Notice of Intent

Type of Action: APD Change

Procedure Description: OXY USA Inc. respectfully requests approval to amend the subject well(s) AAPD to update the production string cement from 13.2ppg Class H/Poz slurry to a 13.3 Class C/Poz slurry. See the attached drill plan revision summaries and lab test for reference. No surface hole changes or additional disturbance are related to this sundry.

Laboratory Cement Test Report
MIX 2023-3651 – OXY – HP479 – CHUCK SMITH MDP1 8_17 FED COM 022H – Production – 13.3ppg
Tail
Service Order: 74499

UCA Compressive Strength

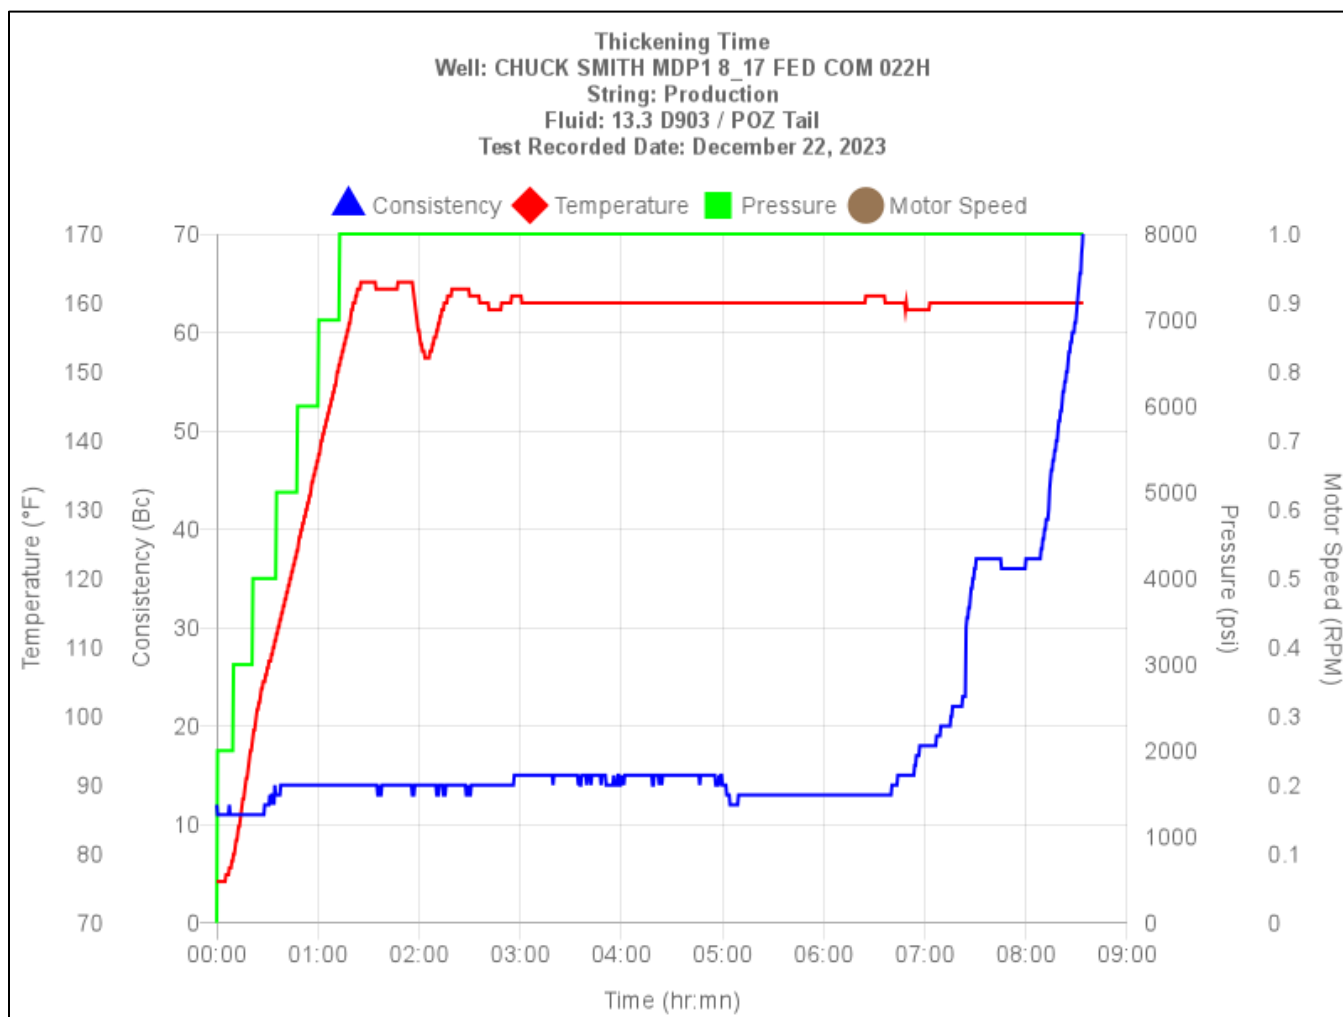
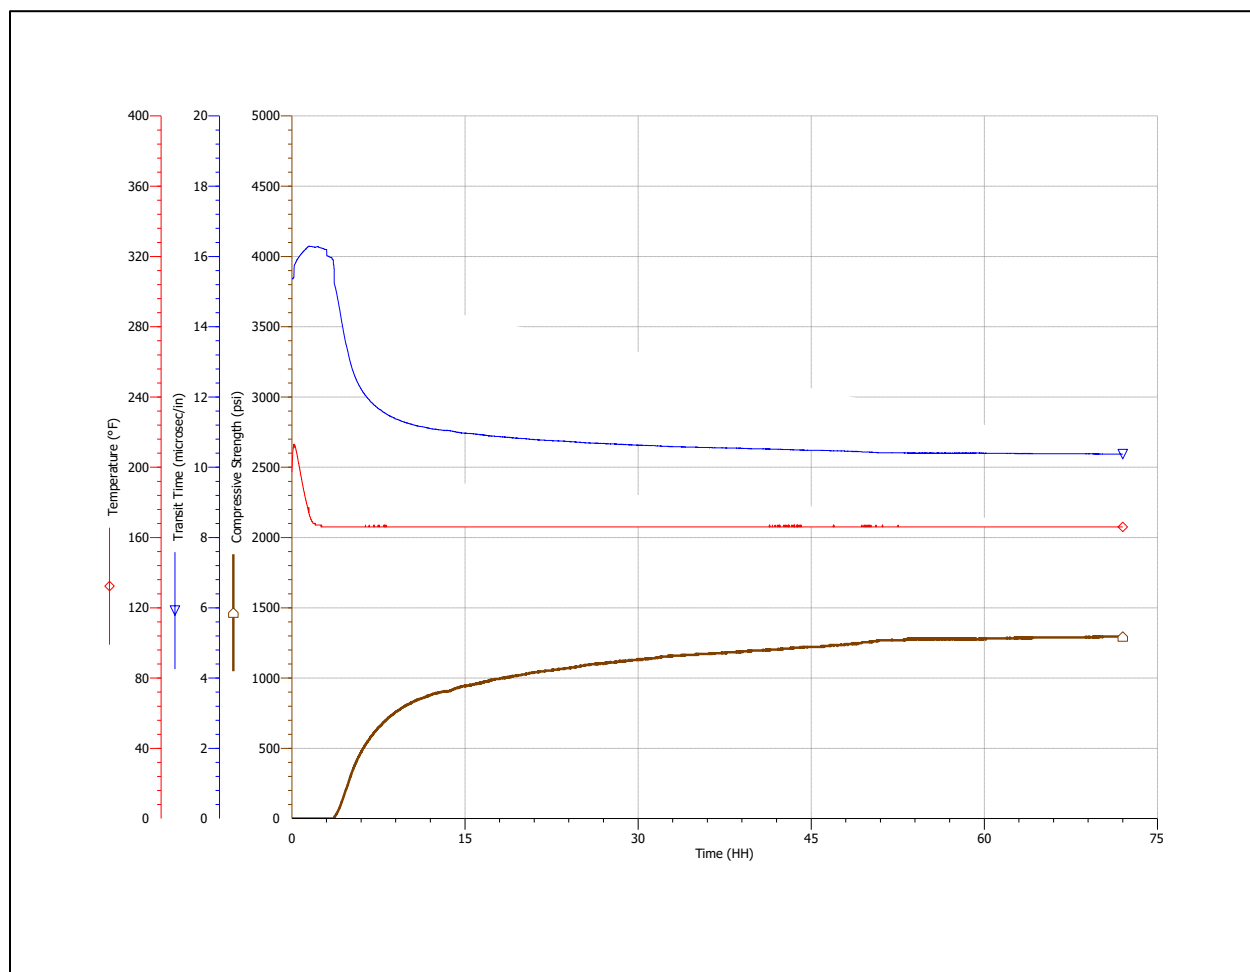
Note: When compared to the Class H / Poz system(s), the Class C / Poz slurry achieved earlier (faster) compressive strength development.

Class H / Poz: 500 psi 13:12 hr:mn

Class C / Poz: 500 psi 06:10 hr:mn

Time	Compressive Strength	Temperature
03:58 hr:mn	50 psi	160 degF
06:10 hr:mn	500 psi	160 degF
24:00 hr:mn	1069 psi	160 degF
48:00 hr:mn	1241 psi	160 degF
72:00 hr:mn	1294 psi	160 degF
Machine S/N:	640
